# PERFORMANCE BULLETIN

March 19, 2003

## 9100 Updates Compared To The 9000

### Screw

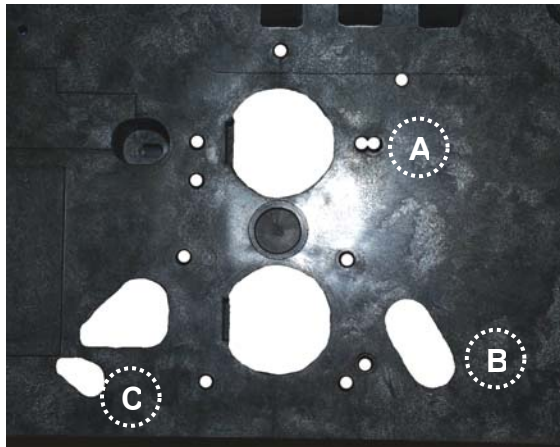
The 14202 screw that holds the connecting yoke assembly for the 9000 2<sup>nd</sup> tank adapter has been shortened and changed to 14202-01. If you do not use the new 14202-01 screw in a 9100, the screw will not tighten the 13255 clip. Performance Bulletin # 387 will also explain the change.

14202-01  
8-32 x 5/16"

New 9000/9100 Backplate

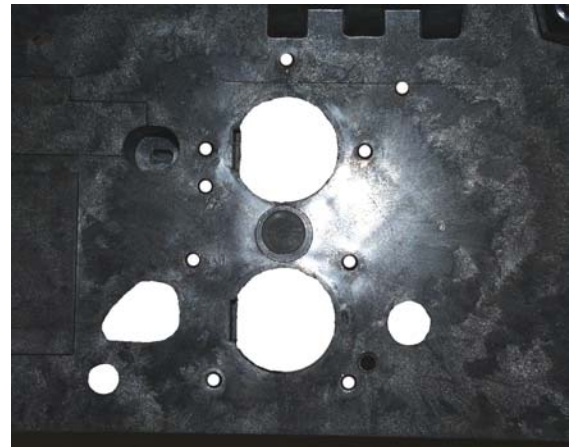
The 9000 backplate has been changed to accommodate the screw location for connecting to the valve body, 2<sup>nd</sup> tank and meter connection for the 9100. If you have an older backplate (powerhead) in stock for a 9000, this will not work on a 9100. The backplate change was in production in late October of 2002.

- A. Extra screw hole for connecting to 9100-valve body.
- B. Larger opening for locating screw for 2<sup>nd</sup> tank connection.
- C. Larger opening for meter screw.

## Inlet/Outlet

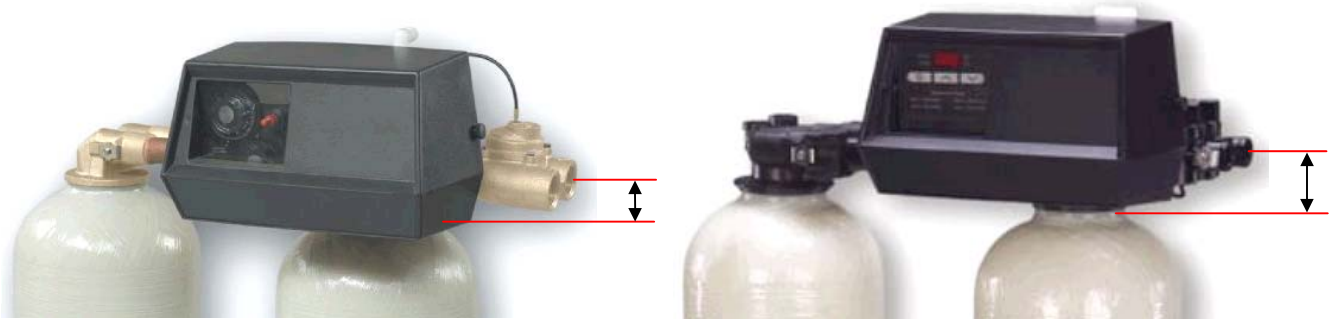
The 9100 control valve inlet/outlet will be about 3/4" higher above the tank than a 9000 control valve. If you were to convert an existing 9000 to a 9100, plumbing changes may be required.

## Injector Drain O-ring

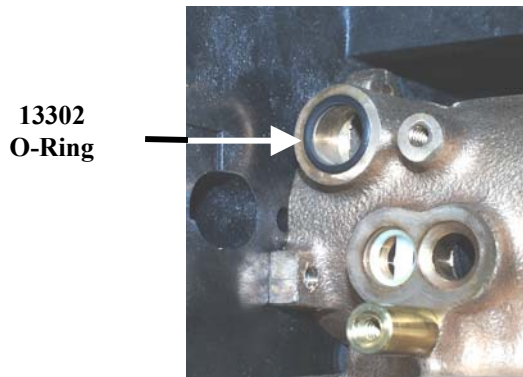
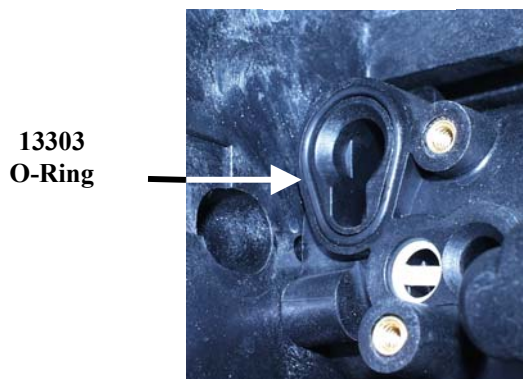
The 9100 injector drain o-ring is larger than the o-ring on the 9000 control valve. When ordering the 60385-XXXX injector assembly, both drain o-rings will be included with the assembly.

60385-XXXX  
With Both Drain O-Rings
